JANUARY 13, 2014

CITY OF PORTLAND
DRAFT Facility Report
Bureau of Transportation

BOT-06: STREET CAR BUILDING
1516 NW NORTHROP STREET, PORTLAND OR

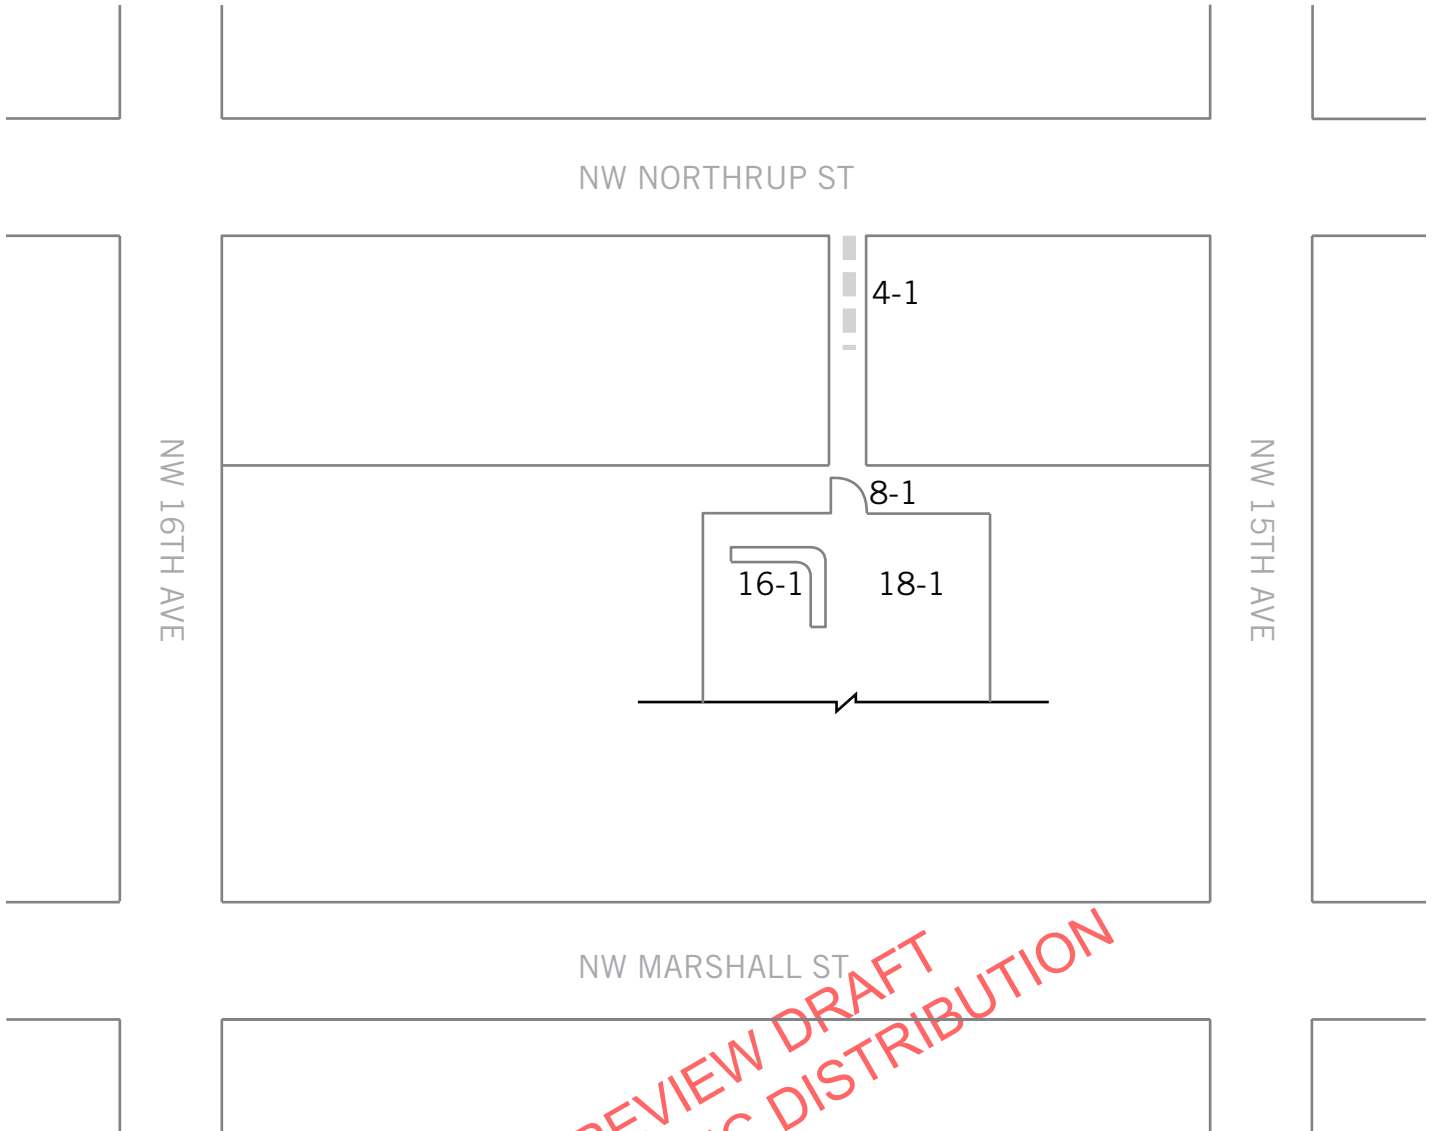
Building	
4 - 1	Walk Category:
Regrade surface	\$630
Notes: Cross slope of concrete path is up to 2.8% for 21 linear feet (2.0% max).	
State: ---	
Federal: 403.3	
8 - 1	Door/Gate Category:
Install sign or modify sign	\$250
Notes: A tactile and Braille EXIT sign is not provided in passageway for emergency exit.	
State: ---	
Federal: 216.4.1, 703.4.1	
16 - 1	Built-in Elements Category:
Provide an accessible counter	\$1,500
Notes: The service counter is 43-3/4" AFF (36" max).	
State: ---	
Federal: 904.4.1	
18 - 1	Room Category:
Attach carpet or tile to the floor surface	\$250
Notes: There are two loose floor rugs inside and outside the room (carpet or tile needs to be securely fastened to the floor).	
State: ---	
Federal: 302.2

FIRST FLOOR

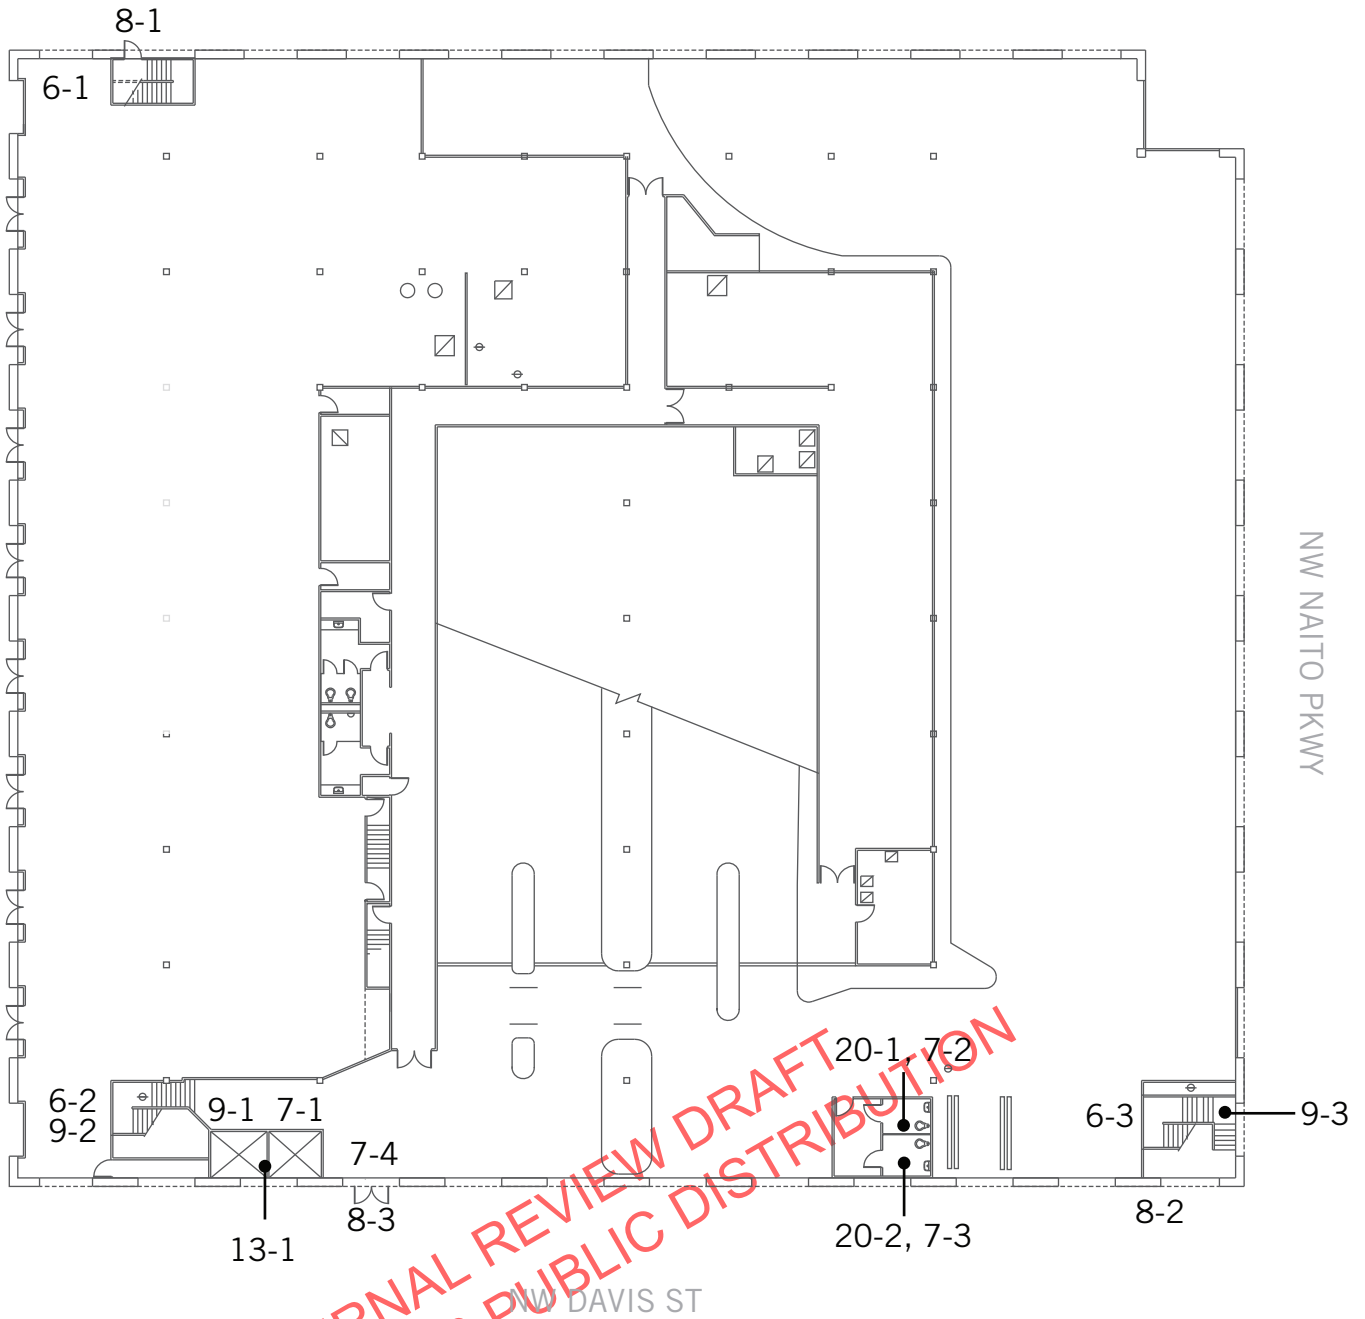
Floor 1		Category:
6 - 1	Stairway	
Replace stairs		\$6,300
<p>Notes: Stairway 1st to 2nd floor has 21 risers and two stair runs (7 and 14 risers). The lower run has tread widths ranging from 10-1/2" to 10-7/8" from riser to riser and the upper run has five tread widths that are 10-7/8" (11" min). The riser heights are 6-1/4" to 7-1/4" (4" min to 7" max with uniform heights req). Slopes of five treads are 2.3% to 3.1% (2.0% max).</p>		
<p>State: ---</p> <p>Federal: 504.02, 504.2, 504.3, 504.4</p>		
Install a handrail		\$2,500
<p>Notes: A handrail is not provided on one side of the stairway (handrails on both sides req) on the upper stair run. A parallel extension is not provided at the top of the handrail (12" min) on one side of the lower and upper stair run. A sloped extension is not provided at the bottom of the handrail (one tread-width min) on the lower stair run.</p>		
<p>State: ---</p> <p>Federal: 505.10.2, 505.10.3, 505.2, 505.3</p>

Raise or lower existing handrail		\$1,400
<p>Notes: Handrail top surface is mounted 30-1/2" to 31-3/8" above the stair nosing (34" min to 38" max).</p>		
<p>State: ---</p> <p>Federal: 505.4</p>		
Install or modify stairway signage		\$250
<p>Notes: Floor level sign does not state the terminus of the exit enclosure or the story of and the direction to the exit discharge (signs provided at each floor landing in an exit enclosure connecting more than three stories). Sign is 15-1/4" square (18" by 12" min). Lettering identifying the stair enclosure is 1" to 1-3/8" (1-1/2" min). Sign is located in the intermediate landing of the stairway (sign located on each floor landing).</p>		
<p>State: ---, 1022.8, 1022.8.1, 1110.2, ANSI 504.9</p> <p>Federal: ---, 216.4.1</p>

Floor 1		Category:
6 - 2	Stairway	
Replace stairs		\$3,000
Notes: Stairway 1st to 2nd floor has 28 risers with three stair runs (11, 8 and 9 risers). The lowest tread on the bottom run has a tread width of 10-3/4" (11" min) and the slopes of the two bottom treads are 2.6% to 2.9% (2.0% max). The middle run tread widths range from 10-5/8" to 10-3/4" on seven of the eight risers (11" min).		
State: ---		
Federal: 504.02, 504.2, 504.3, 504.4		
Install a handrail		\$875
Notes: A 12" parallel extension is not provided at the top of the handrail on one side on the bottom and middle stair runs, and extensions are not provided on both sides of the top stair run. A sloped extension of 10-1/2" is provided at the bottom of the handrail on one side of the middle stair run, and none are provided on the lower stair run (one tread-width min).		
State: ---		
Federal: 505.10.2, 505.10.3, 505.3		
Raise or lower existing handrail		\$2,800

Notes: Handrail top surface is mounted 30-5/8" to 32" above the stair nosing (34" min to 38" max).		
State: ---		
Federal: 505.4		
Install or modify stairway signage		\$250
Notes: The stairway is an exit enclosure connecting more than three stories. A sign designating the floor level, the terminus of the top and bottom of the exit enclosure, identification of the stairway, the story of and direction to the exit discharge, and the availability of roof access is not provided.		
State: 1022.8, 1110.2		
Federal: ---

Floor 1		Category:
6 - 3	Stairway	Category:
Install a handrail		\$750
Notes: Stairway 1st to 2nd floor has 31 risers and four runs (4, 9, 9 and 9 risers). A parallel extension is not provided at the top of the handrail on one side of the stairway (12" min) on all four stair runs. A sloped extension is not provided at the bottom of the handrail (one tread-width min) on the lower run.		
State: ---		
Federal: 505.10.2, 505.10.3		
Raise or lower existing handrail		\$3,100
Notes: Handrail top surface is mounted 31-3/8" to 32-1/4" above the stair nosing (34" min to 38" max).		
State: ---		
Federal: 505.4		
Install or modify stairway signage		\$250
Notes: Floor level sign does not state the terminus of the exit enclosure or the story of and the direction to the exit discharge (signs provided at each floor landing in an exit enclosure connecting more than three stories). Sign is 15-1/4" square (18" by 12" min). Lettering identifying the stair enclosure is 1" to 1-3/8" (1-1/2" min). Sign is located in the intermediate landing of the stairway (sign located on each floor landing).

State: ---, 1022.8, 1022.8.1, 1110.2, ANSI 504.9		
Federal: ---, 216.4.1		
7 - 1	Hazard	Category:
Repair or modify floor surface		\$250
Notes: There are two mats not securely attached to the floor surface (carpet or tile needs to be securely fastened to the floor).		
State: ---		
Federal: 302.2		
7 - 2	Hazard	Category:
Remove overhanging or protruding objects		\$125
Notes: Hand dryer protrudes 5-1/2" from wall at 40-5/8" AFF (protrusion more than 4" must be mounted below 27" or above 80").		
State: ---		
Federal: 307.2

Floor 1		
7 - 3	Hazard	Category:
Remove overhanging or protruding objects		\$125
Notes: Hand dryer protrudes 5-1/2" from wall at 40-3/8" AFF (protrusion more than 4" must be mounted below 27" or above 80").		
State: ---		
Federal: 307.2		
7 - 4	Hazard	Category:
Repair or modify floor surface		\$125
Notes: There is one mat not securely attached to the floor surface.		
State: ---		
Federal: 302.2		
8 - 1	Door/Gate	Category:
Replace door hardware		\$425
Notes: Door to stairwell. The door handle requires grasping and twisting to operate.		
State: ---		
Federal: 309.4		
8 - 2	Door/Gate	Category:
Adjust door closer		\$125
Notes: Door to stairwell. The door closer sweep time is 3 seconds (5 seconds min). Door opening force is 12 lbs (8-1/2 lbs max for exterior door).		
State: ---, 1101.2.2.5		
Federal: 404.2.8.1, 404.2.9		
Replace door hardware		\$425
Notes: Door handle requires grasping and twisting to operate.		
State: ---

Federal: 309.4		
8 - 3	Door/Gate	Category:
Install sign or modify sign		\$250
Notes: A tactile and Braille EXIT sign is not provided in passageway for emergency exit.		
State: ---		
Federal: 216.4.1, 703.4.1		
Adjust door closer		\$125
Notes: Door closer sweep time is 3 seconds on the west leaf of the double door (5 seconds min).		
State: ---		
Federal: 404.2.8.1

Floor 1		
9 - 1	Sign	Category:
Relocate existing sign		\$125
Notes: "Attention!" sign lettering is 39" above the ground (40" min).		
State: ---		
Federal: 703.5.6		
9 - 2	Sign	Category:
Relocate existing sign		\$125
Notes: "Have you PAID for your Parking?" sign lettering is 38-7/8" above the ground (40" min).		
State: ---		
Federal: 703.5.6		
9 - 3	Sign	Category:
Relocate existing sign		\$125
Notes: "Have you PAID for your Parking?" sign lettering is 29-1/8" above the ground (40" min).		
State: ---		
Federal: 703.5.6		
13 - 1	Elevator	Category:
Adjust elevator controls and labeling		\$40,000
Notes: Car controls for the fire call button are located 58-1/4 AFF (15" min to 48"max, 54" max for existing elevators) in both elevator cars.		
State: ---		
Federal: 308.2.1, 308.3.1, 407.2.1, 407.4.7.1.3, 703.2.5, 703.3.1		
Adjust or provide elevator signals and indicators		\$5,600
Notes: Hallway signals indicating which car is answering and the direction of travel are not operable. The up arrow on the two cars is not functional.

State: ---		
Federal: 407.2.2.1		
Install or modify informational and directional signs		\$1,500
Notes: Elevator landings above the ground floor do not provide signage indicating the location of the other means of egress, and which are the accessible means of egress.		
State: 1007.10, 1110.2		
Federal: ---

Floor 1	
20 - 1	Single User Restroom
Category:	
Provide clear floor or turning space	\$3,000
Notes: A 60" min diameter turning space unobstructed from the floor to a height of 27" min is not provided.	
State: ---	
Federal: 304.3.1, 306.3, 603.3.2.1	
Install restroom sign	\$250
Notes: A tactile and Braille restroom sign is not provided.	
State: ---	
Federal: 703, 703.4.1, 703.4.2	
Modify stall partitions	\$500
Notes: Clear width over water closet is 34-7/8" (60" min) to the lavatory.	
State: ---	
Federal: 604.3.1	
Regrade surface	\$3,000
Notes: Slope near the drain in the center of the room is 2.6% (2.0% max).	
State: ---	
Federal: 305.2	
Insulate hot water lines	\$125
Notes: Lavatory drain pipes are not insulated.	
State: ---	
Federal: 606.5	
Reposition toilet flush controls	\$750
Notes: Operating effort of flush control is 13 lbs (5 lbs max). Flush control is not located on the wide side of the water closet.	
State: ---

Federal: 604.6	
Replace or modify grab bars	\$600
Notes: Rear grab bar is 29-3/4" long (36" long min, extends 12" and 24" min from centerline of water closet). A side grab bar is not provided (42" long min; starts 12" max from the rear wall and ends 54" min from the rear wall).	
State: ---	
Federal: 604.5.2, 609.5.1	
Modify grab bars	\$0
Notes: Rear grab bar is 36-3/4" AFF (33" min to 36" max).	
State: ---	
Federal: 609.4

Floor 1	
20 - 2	Single User Restroom
Category:	
Install restroom sign	\$250
Notes: A tactile and Braille restroom sign is not provided.	
State: ---	
Federal: 703, 703.4.1, 703.4.2	
Provide clear floor or turning space	\$3,000
Notes: A 60" min diameter turning space unobstructed from the floor to a height of 27" min is not provided.	
State: ---	
Federal: 304.3.1, 306.3, 603.3.2.1	
Modify grab bars	\$400
Notes: Side grab bar is 36-5/8" to 37-1/4" AFF (33" min to 36" max). Rear grab bar is 37-1/4" AFF (33" min to 36" max).	
State: ---	
Federal: 609.4	
Modify stall partitions	\$500
Notes: Clear width over water closet is 35-1/2" (60" min) to the lavatory.	
State: ---	
Federal: 604.3.1	
Insulate hot water lines	\$125
Notes: Lavatory drain pipes are not insulated.	
State: ---	
Federal: 606.5	
Replace or adjust water controls	\$500
Notes: Operating effort of lavatory faucet is 7 lbs and 8 lbs (5 lbs max). Water flows from faucet for 6 seconds and 8 seconds (10 seconds min).

State: ---	
Federal: 309.4, 606.4	
Modify operating mechanism	\$250
Notes: Operating effort of hand dryer is 7 lbs (5 lbs max).	
State: ANSI 606.7	
Federal: 309.4	
Reposition toilet flush controls	\$750
Notes: Operating effort of flush control is 19-1/2 lbs (5 lbs max). Flush control is not located on the wide side of the water closet.	
State: ---	
Federal: 604.6

Floor 1	
20 - 2	Single User Restroom
Category:	
Regrade surface	\$3,000
Notes: Slope near the drain in the center of the room is 3.8% (2.0% max).	
State: ---	
Federal: 305.2	
Modify lavatory or counter clearances	\$1,500
Notes: Knee space measured at 8" deep from the centerline of the lavatory is 26-3/4" AFF (27" min).	
State: ---	
Federal: 306.3, 306.3.3

SECOND FLOOR

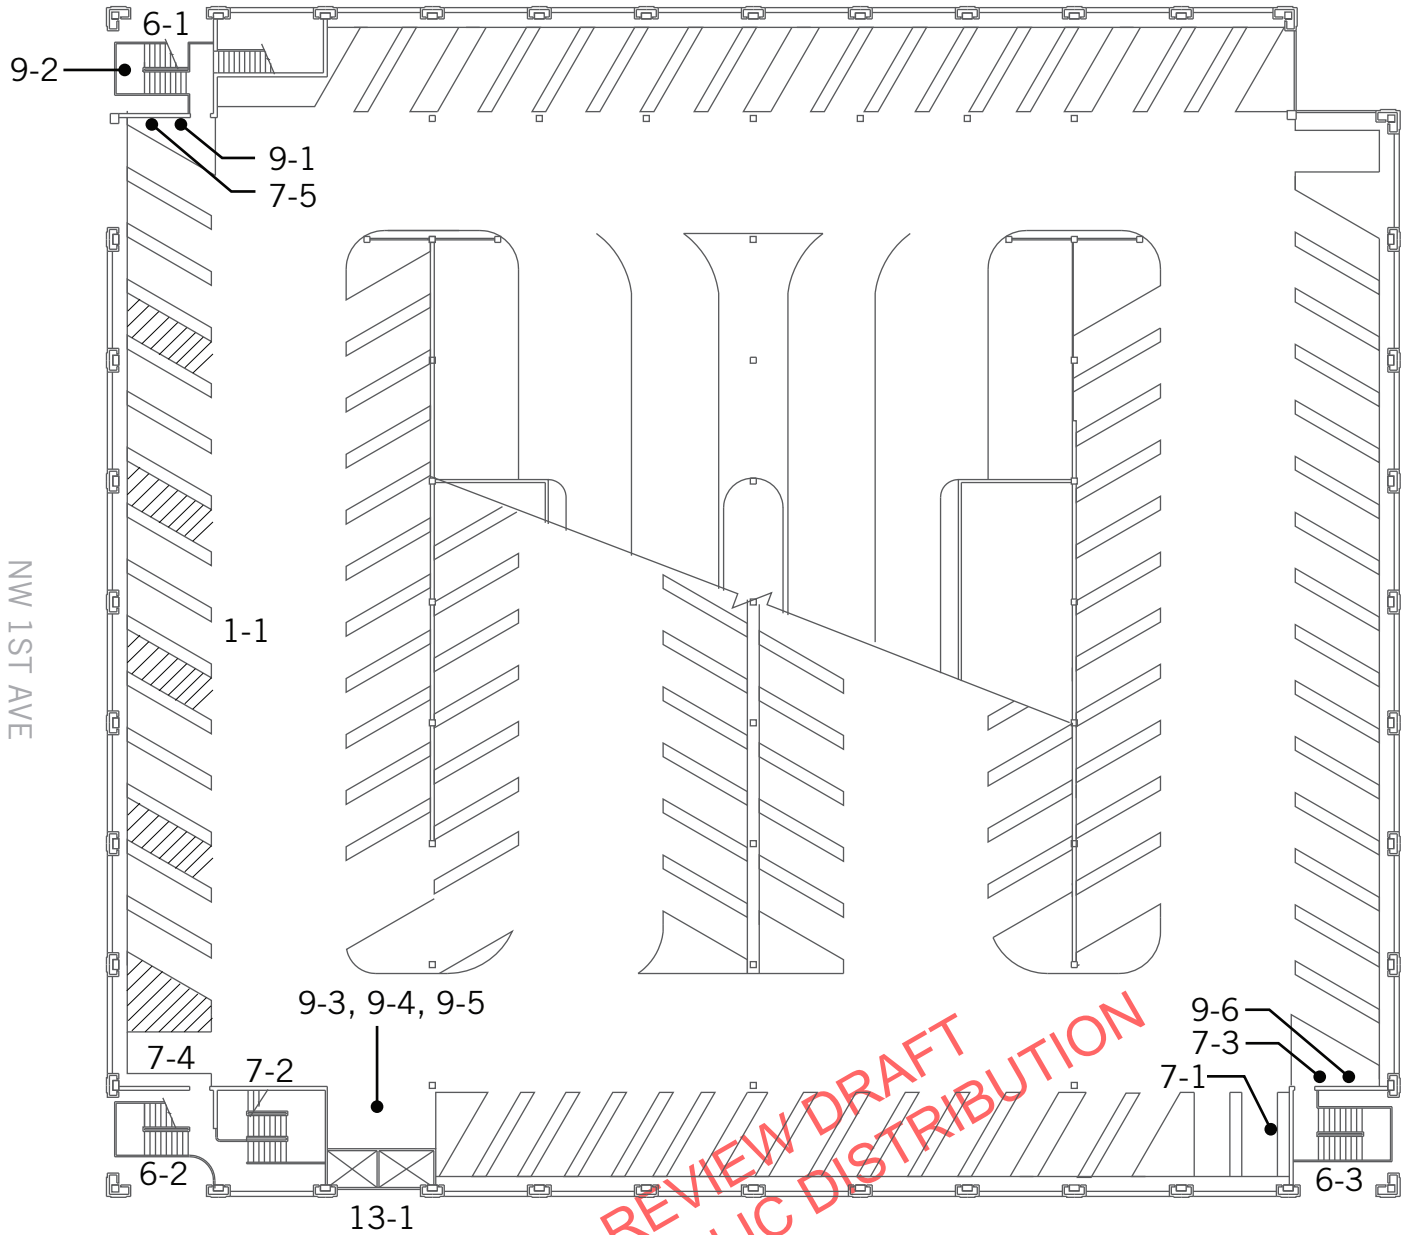
Floor 2	
1 - 1	Parking Area
Category:	
Provide or modify accessible spaces	\$5,890
Notes: Total number of parking garage spaces is 449. The total number of accessible parking spaces provided is 10. Van accessible spaces are not provided (2 van accessible spaces min).	
State: 1106.7.1	
Federal: 208.2.4	
Provide a pavement stencil	\$2,100
Notes: A pavement International Symbol of Accessibility, painted with retroreflective white paint is not provided in any of the designated accessible parking spaces.	
State: 1106.7.2	
Federal: 502.6	
Install reserved parking sign	\$3,750
Notes: Blue and white ISA signs provided. Required: A "Reserved Parking" sign 12" wide by 18" high, with a green legend and a white ISA on blue symbol, all on a white retroreflective background.	
State: 1106.7.2	
Federal: 502.6, 703.7.2.1	
Install van accessible sign	\$750
Notes: A "Van Accessible" sign is not provided. Required: A "Van Accessible" sign that is 18" wide by 9" high on a white retroreflective background and green retroreflective lettering provided at each van accessible space.

State: 1106.5	
Federal: 208.2.4, 502.6	
Remove overhanging or protruding objects	\$0
Notes: Vertical clearance for accessible parking spaces and access aisles and the vehicle route from the entrance is 84-1/2" to 85-1/2" (98" min for one van accessible space).	
State: ---	
Federal: 502.5

Floor 2	
6 - 1	Stairway
Category:	
Replace stairs	\$3,900
<p>Notes: Stairway 2nd to 3rd floor has 18 risers and two stair runs (9 and 9 risers). The lower run has tread width ranging from 10-3/4" to 10-7/8" from riser to riser (11" min) with riser heights that are 6-1/4" to 7-1/2" (4" min to 7" max). The upper stair run has four treads with slopes ranging from 2.6% to 3.2% (2.0% max).</p>	
<p>State: ---</p> <p>Federal: 504.02, 504.2, 504.3</p>	
Install a handrail	\$500
<p>Notes: A parallel extension is not provided at the top of the handrail on one side of the stairway (12" min) on both the upper and lower stair runs. Sloped extensions are not provided at the bottom of the lower stair run handrails (one tread-width min).</p>	
<p>State: ---</p> <p>Federal: 505.10.2, 505.10.3</p>	
Raise or lower existing handrail	\$1,800
<p>Notes: Handrail top surface is mounted 31-1/4" to 32" above the stair nosing (34" min to 38" max).</p>

<p>State: ---</p> <p>Federal: 505.4</p>	
Install or modify stairway signage	\$500
<p>Notes: Floor level sign does not state the terminus of the exit enclosure or the story of and the direction to the exit discharge (signs provided at each floor landing in an exit enclosures connecting more than three stories). Sign is 15-1/4" square (18" by 12" min). Lettering identifying the stair enclosure is 1" to 1-3/8" (1-1/2" min). Sign is located in the intermediate landing of the stairway (sign located on each floor landing). A tactile and Braille EXIT sign is not provided.</p>	
<p>State: ---, 1022.8, 1022.8.1, 1110.2</p> <p>Federal: ---, 216.4.1</p>

Floor 2		Category:
6 - 2	Stairway	
Replace stairs		\$3,300
Notes: Stairway 2nd to 3rd floor has 18 risers and two stair runs (9 and 9 risers). On the lower stair run, the slope of the bottom tread is 4.1% and the top tread is 3.7% (2.0% max). On the upper stair run, the bottom riser height is 5-3/4", while others are 6-1/4" to 6-3/4" (uniform heights req).		
State: ---		
Federal: 504.2, 504.4		
Install a handrail		\$500
Notes: A parallel extension is not provided at the top of the handrail on one side of the stairway (12" min) on both the upper and lower stair runs. Sloped extensions are not provided at the bottom of the lower stair run handrails (one tread-width min).		
State: ---		
Federal: 505.10.2, 505.10.3		
Raise or lower existing handrail		\$1,800
Notes: Handrail top surface is mounted 31-1/8" to 32-1/8" above the stair nosing (34" min to 38" max).		
State: ---		
Federal: 505.4		
Install or modify stairway signage		\$500

Notes: Floor level sign does not state the terminus of the exit enclosure or the story of and the direction to the exit discharge (signs provided at each floor landing in an exit enclosures connecting more than three stories). Sign is 15-1/4" square (18" by 12" min). Lettering identifying the stair enclosure is 1" to 1-3/8" (1-1/2" min). Sign is located in the intermediate landing of the stairway (sign located on each floor landing). A tactile and Braille EXIT sign is not provided.		
State: ---, 1022.8, 1022.8.1, 1110.2		
Federal: ---, 216.4.1

Floor 2		Category:
6 - 3	Stairway	Category:
Replace stairs		\$900
Notes: Stairway 2nd to 3rd floor has 18 risers and two stair runs (9 and 9 risers). On the lower stair run, the slope of the third tread from the bottom is 2.7% and on the upper stair run the third tread from the bottom and first tread from top are 2.9% and 2.8% (2.0% max).		
State: ---		
Federal: 504.4		
Install a handrail		\$250
Notes: A parallel extension is not provided at the top of the handrail on one side of the stairway (12" min) on both the upper and lower stair runs.		
State: ---		
Federal: 505.10.2		
Raise or lower existing handrail		\$1,800
Notes: Handrail top surface is mounted 31-1/4" to 32" above the stair nosing (34" min to 38" max).		
State: ---		
Federal: 505.4		
Install or modify stairway signage		\$500
Notes: Floor level sign does not state the terminus of the exit enclosure or the story of and the direction to the exit discharge (signs provided at each floor landing in an exit enclosures connecting more than three stories). Sign is 15-1/4" square (18" by 12" min). Lettering identifying the stair enclosure is 1" to 1-3/8" (1-1/2" min). Sign is located in the intermediate landing of the stairway (sign located on each floor landing). A tactile and Braille EXIT sign is not provided.

State: ---, 1022.8, 1022.8.1, 1110.2		
Federal: ---, 216.4.1		
7 - 1	Hazard	Category:
Remove overhanging or protruding objects		\$125
Notes: Fire extinguisher protrudes 6-1/2" from wall at 37-3/8" AFF (protrusion more than 4" must be mounted below 27" or above 80").		
State: ---		
Federal: 307.2		
7 - 2	Hazard	Category:
Remove overhanging or protruding objects		\$125
Notes: Fire extinguisher protrudes 6-1/2" from wall at 30" AFF (protrusion more than 4" must be mounted below 27" or above 80").		
State: ---		
Federal: 307.2

Floor 2		
7 - 3	Hazard	Category:
Remove overhanging or protruding objects		\$125
Notes: Water valve protrudes 12" from wall at 54-3/8" AFF (protrusion more than 4" must be mounted below 27" or above 80").		
State: ---		
Federal: 307.2		
7 - 4	Hazard	Category:
Remove overhanging or protruding objects		\$125
Notes: Water valve protrudes 16" from wall at 41-1/4" AFF (protrusion more than 4" must be mounted below 27" or above 80").		
State: ---		
Federal: 307.2		
7 - 5	Hazard	Category:
Remove overhanging or protruding objects		\$125
Notes: Water valve protrudes 13" from wall at 45-1/4" AFF (protrusion more than 4" must be mounted below 27" or above 80").		
State: ---		
Federal: 307.2		
9 - 1	Sign	Category:
Relocate existing sign		\$125
Notes: "Smart Park Level 2" sign lettering is 37-7/8" above the ground (40" min).		
State: ---		
Federal: 703.5.6		
Install or modify permanent room sign		\$250
Notes: "Smart Park Level 2" sign has a high gloss finish (non-glare finish).

State: ---		
Federal: 703.5.1		
9 - 2	Sign	Category:
Relocate existing sign		\$125
Notes: "Have you PAID for your Parking?" sign lettering is 34-1/2" above the ground (40" min).		
State: ---		
Federal: 703.5.6

Floor 2	
9 - 3	Sign Category:
Relocate existing sign	\$125
Notes: "Smart Park Level 2" sign lettering is 38-1/2" above the ground (40" min).	
State: ---	
Federal: 703.5.6	
9 - 4	Sign Category:
Relocate existing sign	\$125
Notes: "Attention!" sign lettering is 39-1/4" above the ground (40" min).	
State: ---	
Federal: 703.5.6	
9 - 5	Sign Category:
Relocate existing sign	\$125
Notes: "Pay at pay station" sign lettering is 13" to 13-1/4" above the ground (40" min).	
State: ---	
Federal: 703.5.6	
9 - 6	Sign Category:
Relocate existing sign	\$125
Notes: "Smart Park Level 2" sign lettering is 38" above the ground (40" min).	
State: ---	
Federal: 703.5.6	
Install or modify permanent room sign	\$250
Notes: "Smart Park Level 2" sign has a high gloss finish (non-glare finish).	
State: ---	
Federal: 703.5.1

Floor 2	
13 - 1 Elevator	Category:
Increase or provide clear floor space	\$1,000
Notes: Slope of the clear floor space at the hallway call buttons is 2.4% (2.0% max) on Level 2.	
State: ---	
Federal: 305.2, 407.2.1.3	
Adjust or provide elevator signals and indicators	\$2,500
Notes: Hallway call buttons do not indicate when the call is registered and answered on Level 2.	
State: ---	
Federal: 407.2.1.5
